**RE:** Wellington Prep Plant(C/007/0012): Slurry Pond Fines Removal for Reclamation

# Wellington Preparation Plant (C/007/0012) Mining & Reclamation Plan

## SLURRY FINES REMOVAL FOR RECLAMATION

### Deficiencies, Comments & Insertion Instructions

LOCATION OF THE  
SLURRY FINES REMOVAL  
OPERATIONS  
Phase I  
December 2014

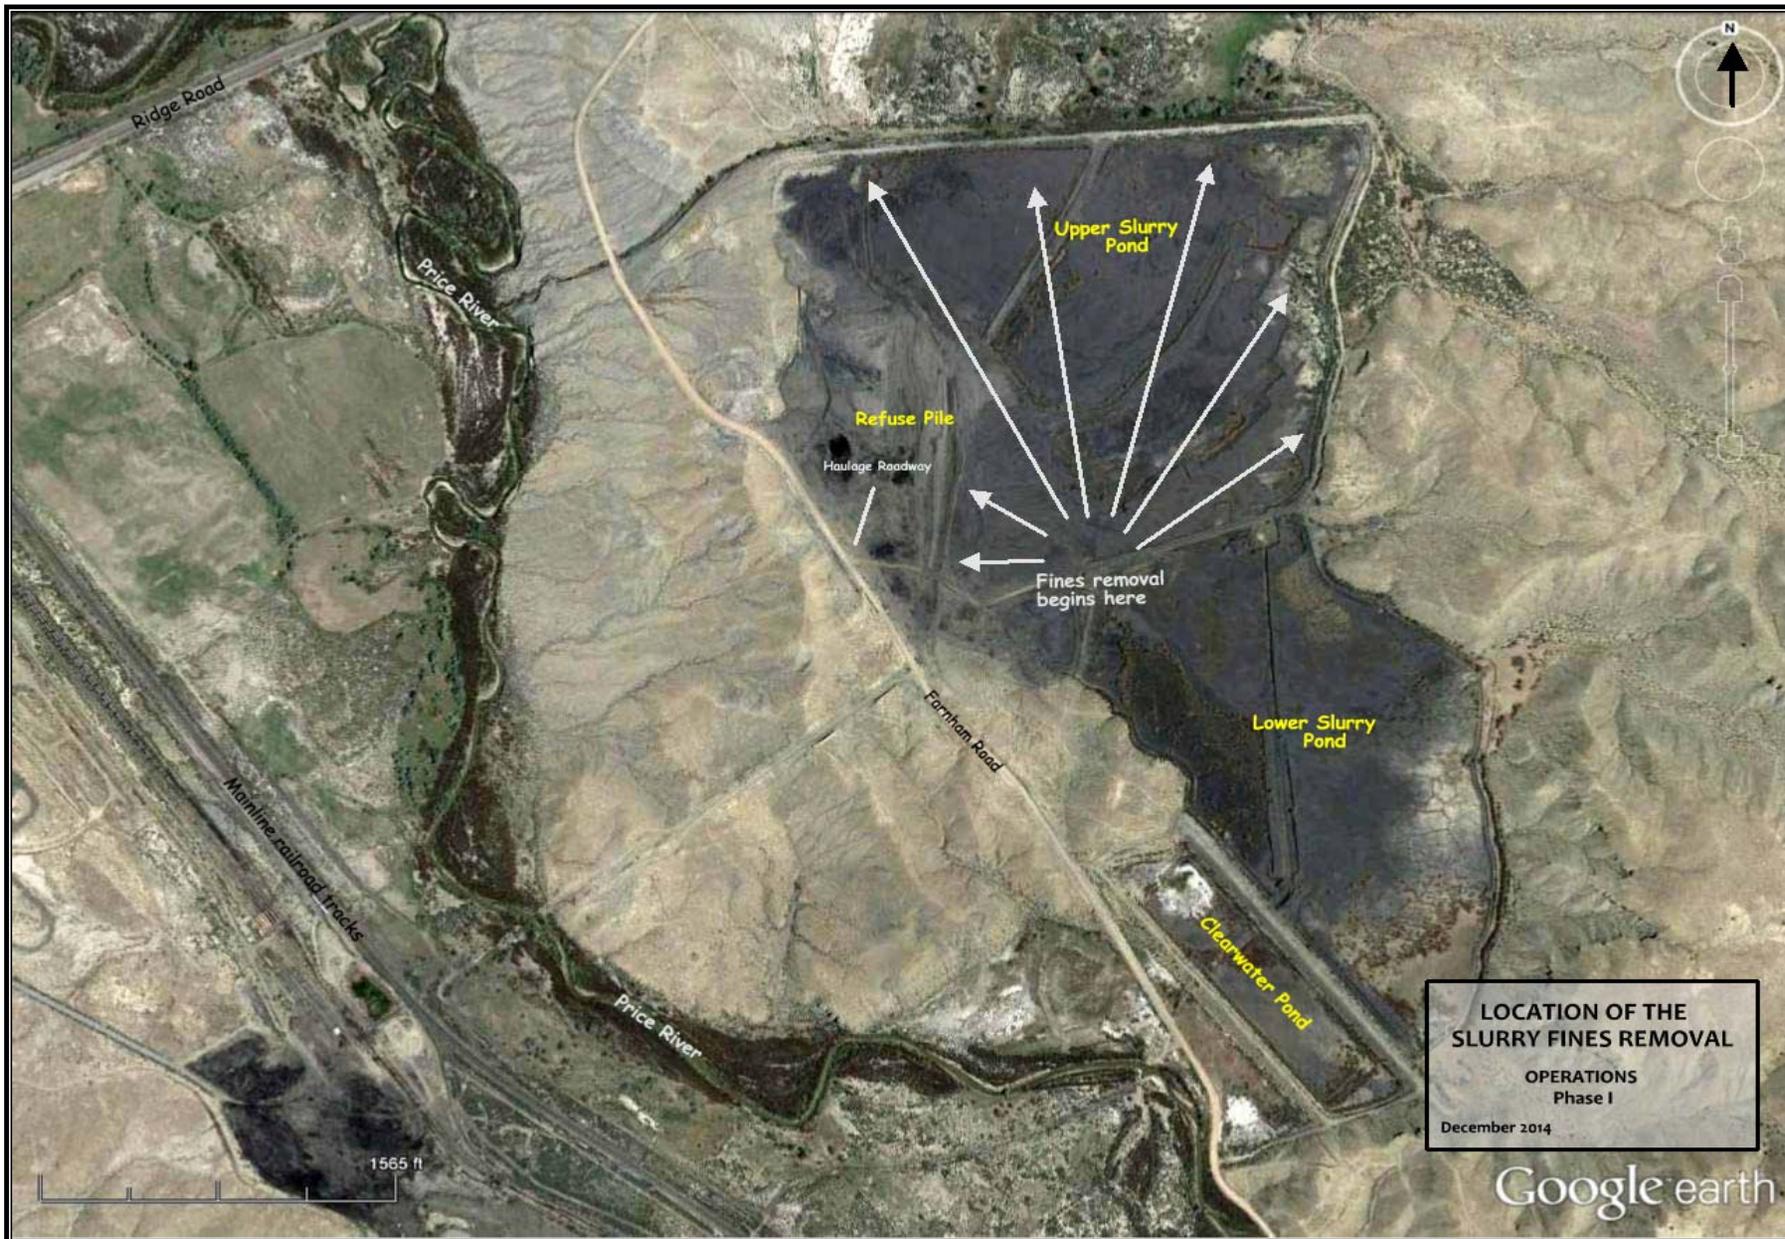
PRT has described the proposed fines re-mining methods and equipment to be used for the operations. As explained in the amendment, the methods and locations for the fines removal at the site will be refined once the process begins and the conditions encountered onsite are better known.

The methods and locations for the fines removal at the site will be refined once the process begins and the conditions encountered onsite are better known. A figure showing the location of the operations and the direction in which the process will continue for the Phase I is provided below.
